Zuba Product Announcement 400-15-001

Subject: Changes to Zuba Central Package 3 model BVRMC1137S001-D4

BVRMC1137S001-D3 -Existing Zuba Package 3 System	**BVRMC1137S001-D4** –New Zuba Package 3 System

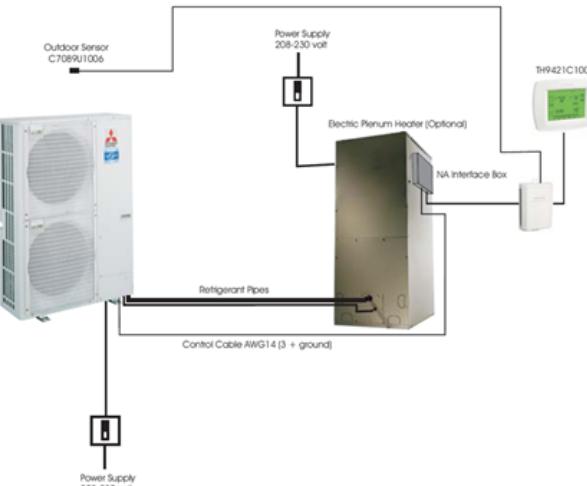
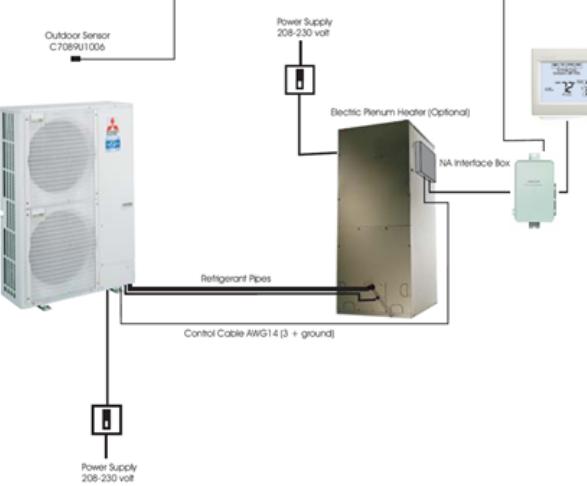
Please be advised of the following information which outlines new model changes for Zuba central package 3. We will move from the current model BVRMC1137S001-D3 to BVRMC1137S001-**D4**. Both physical and operating specifications remain the same. The changes between the models include a new Honeywell thermostat with added features.

The tables below outline the changes between both models.   The new controller is backwards compatible and can be used with existing Zuba central package 3 and package 4 (the equipment interface must be changed on the existing Zuba central system)

Discontinued Model	New Model	Features of New Thermostat
TH9421C1046	**TH8321R1001**	✓ WiFi compatible (requires Honeywell internet gateway model THM6000R) ✓ Smart phone/device control ✓ Touch screen & back light ✓ Wireless installation and operation ✓ 7 day 4 pattern program with override ✓ Auto change over mode ✓ Error indication ✓ Outdoor temperature display ✓ Indoor humidity display ✓ Ventilation control Humidity control
THM5421C1040	**THM5421R1021**
